BEECH 18 UNDERCARRIAGE FORK CAP
MODIFICATION

CLM. NO. 15305

404-188402-2

UNDER CARRIAGE CAP

FIG. 1

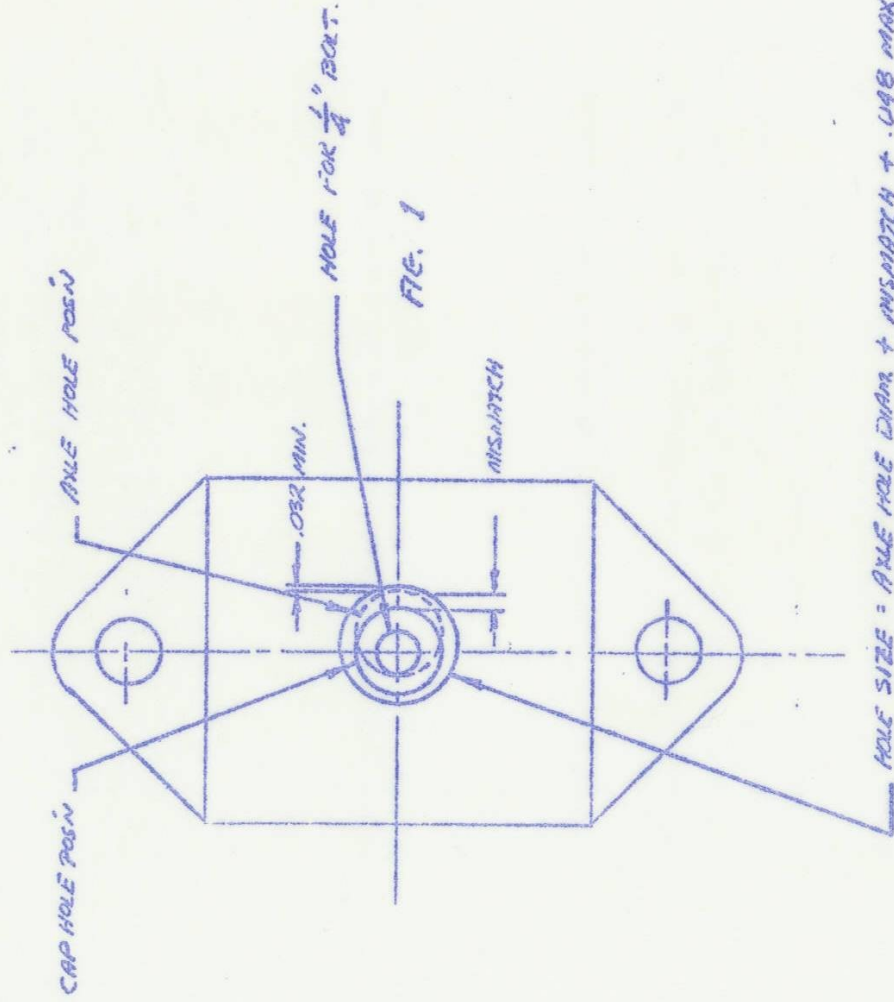
MISMATCH EXISTS BETWEEN HOLE IN UNDERCARRIAGE AXLE CAP AND AXLE.

1. DETERMINE AMOUNT OF MISMATCH BY USING AN OFFSET SCRIBER. PAINT MACHINIST BLUE ON CAP AND SCRIBE AXLE HOLE POSN ON CAP.
2. BORE OUT CAP SUCH THAT NEW HOLE DURN IS AS SHOWN IN FIG. 1.
3. HARDNESS TEST CAP. FABRICATE BLANK BUSHING FROM ETTNER SPS 245, 4130, OR 4340 STEEL OF THE SAME HARDNESS. ALLOW FOR A PRESS FIT OF .0005 - .001 IN CAP. SEE FIG. 2.
4. INSTALL BLANK BUSHING IN CAP USING LOC-TITE, ALLOW SUFFICIENT TIME TO CURE AND THEN BOLT CAP IN POSN ON UNDER CARRIAGE LEG.

5. LOCATE $\frac{1}{2}$ " HOLE IN USING BY DRILLING FROM AXLE HOLE.
6. REMOVE CAP, FINISH BIRING AND ELONGATE $\frac{1}{4}$ " HOLE IN CAP TO LINE UP WITH $\frac{1}{4}$ " HOLE IN 112-29020-7 TORQUE PIN.

HOLE SIZE = AXLE HOLE DIAM + MISMATCH + .048 MAX.
